DUKE POWER COMPANY
OCONEE NUCLEAR STATION

Attachment 2

No Significant Hazards Consideration Evaluation

Oconee Unit 3, Cycle 11 Reload Report

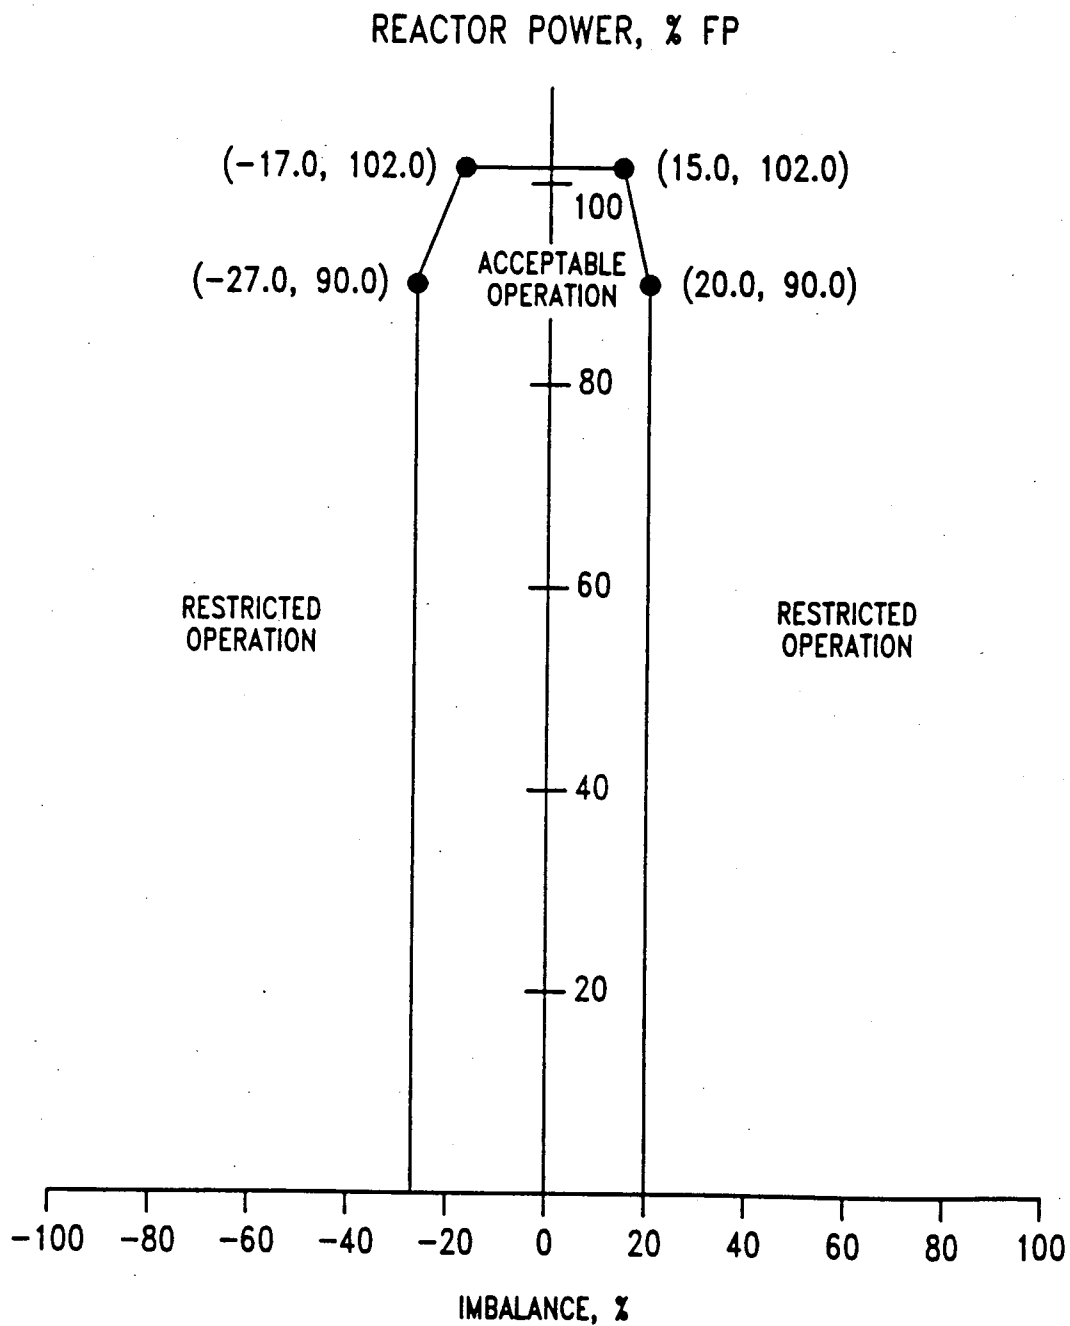
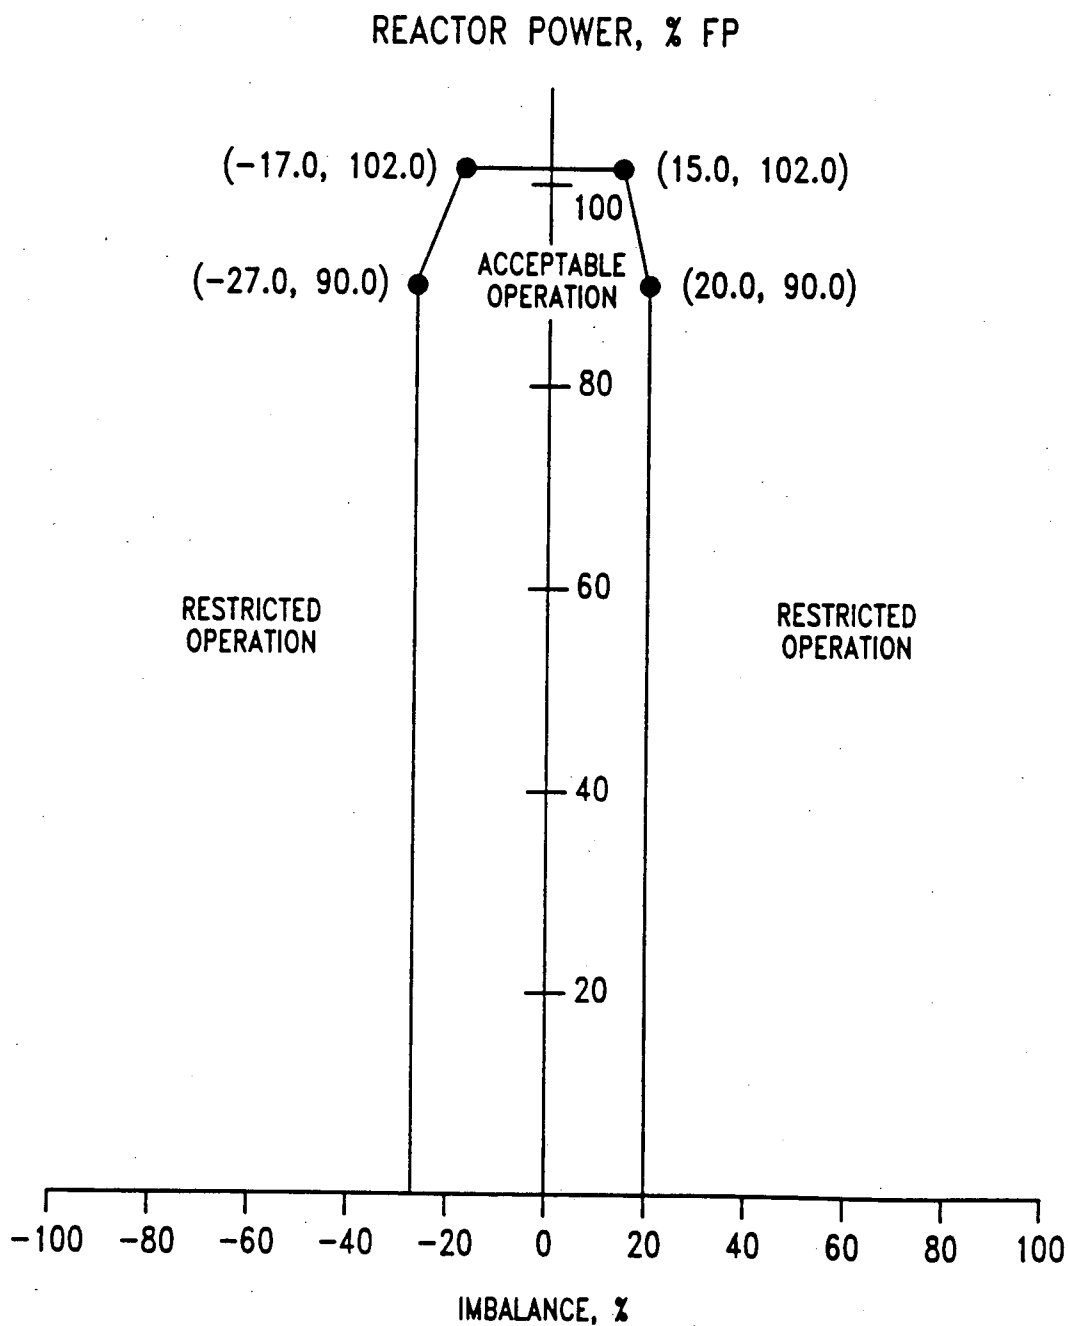
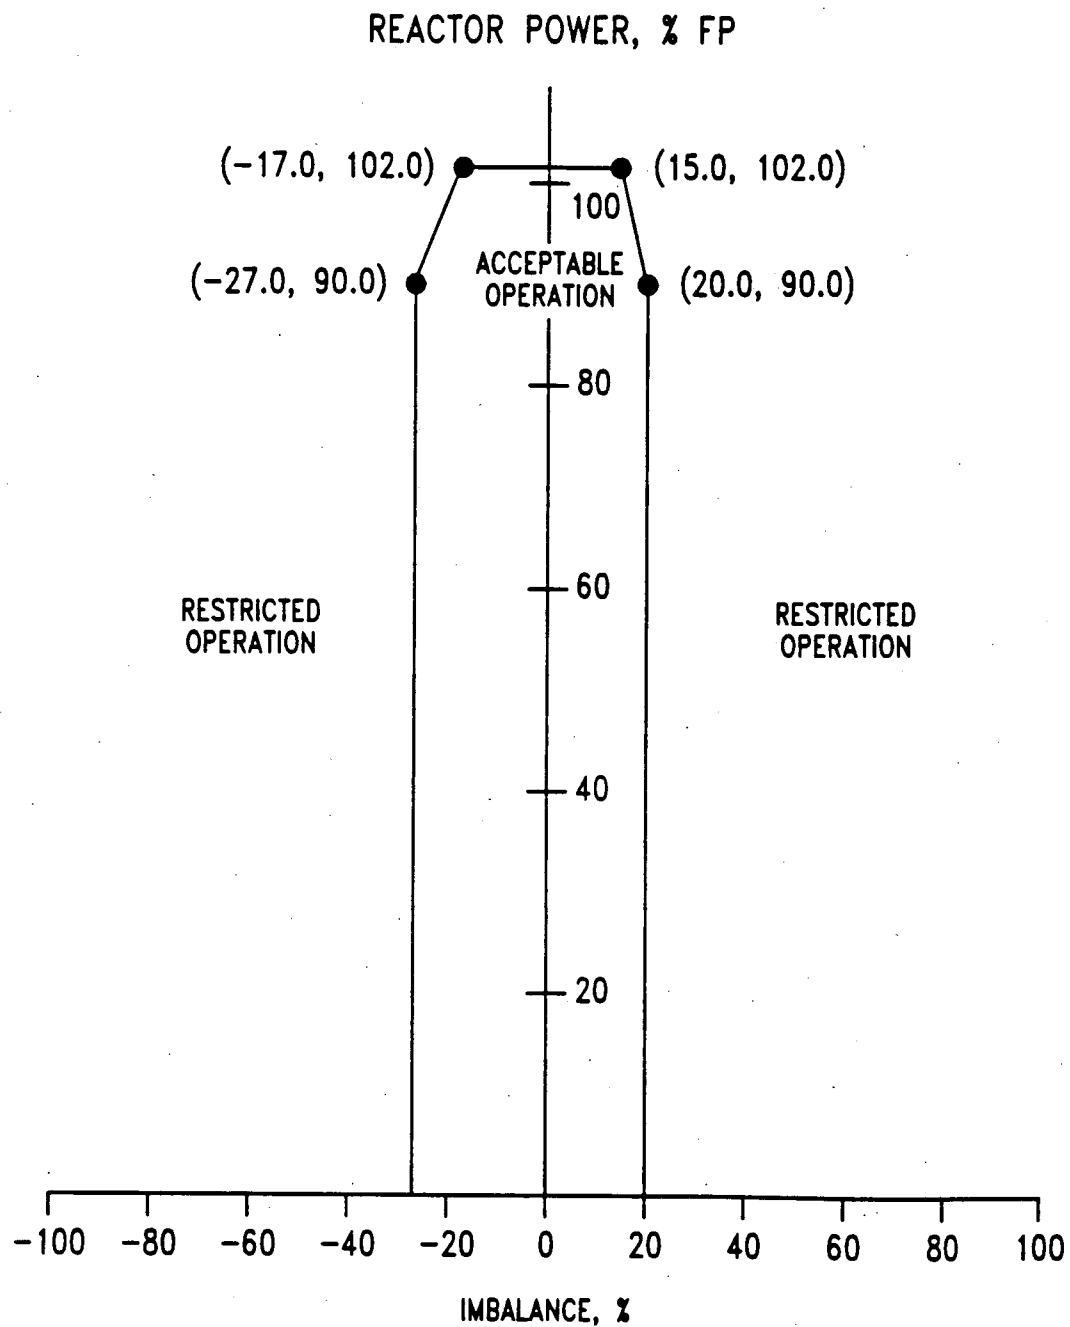
- 6) Pages 3.5-24, -25, -26. Figures 3.5.2-10, -11, -12 Operational Power Imbalance Envelope have been updated to provide a more conservative envelope for all three units. These limits were developed in accordance with the LOCA linear heat rate limits discussed in Section 7 of the reload report and the operational DNB limits based on methods described in Section 6 of the reload report.
- 7) Page 3.8-3. The Bases of Specification 3.8 Fuel Loading and Refueling have been updated to provide consistency with the revised minimum BWST boron concentration. In addition, the footnote regarding Unit 3, Cycle 10 BWST boron concentration has been deleted as the 2010 ppm limit is not applicable to Cycle 11.

Changes to the Operational Power Imbalance Envelope (Figures 3.5.2-10, -11, -12) provide more conservative envelopes for all three units. The revised Operational Power Imbalance Envelope ensures that the initial power distributions assumed for a LOCA or a loss of flow accident remain bounding. As such, this change will not involve a significant increase in the probability or consequences of accidents previously evaluated.

Analysis of the changes to the Operational Power Imbalance Envelope (Figures 3.5.2-10, -11, -12) has indicated that the proposed envelopes are more conservative than those presently included in the Technical Specifications. As a result, this change will not create the possibility of a new or different kind of accident from accidents previously evaluated.
